# **STATEMENT OF ENVIRONMENTAL EFFECTS**

**SECTION 4.55 (1A) MODIFICATION TO APPROVED DA2023/1210**

**33 JOHN STREET, AVALON**

**LOT 11      DP 251931**

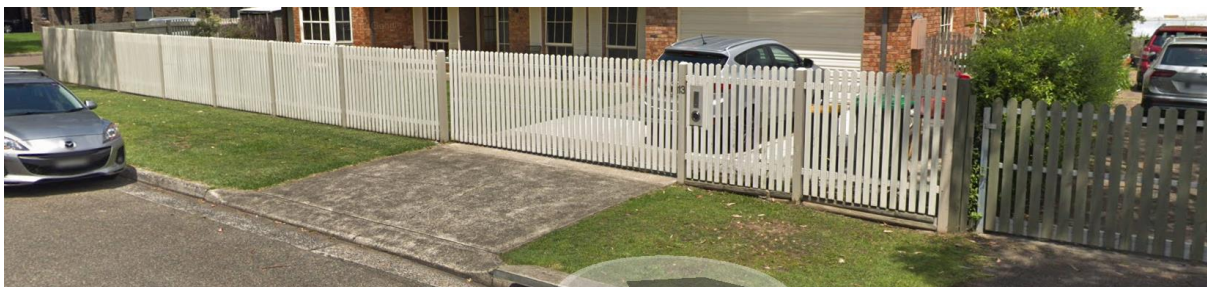
**Approved front boundary fence to be deleted and existing fence to remain**

APPROVED FRONT BOUNDARY FENCE TO BE DELETED AND THE EXISTING FENCE ( ABOVE)  
TO REMAIN
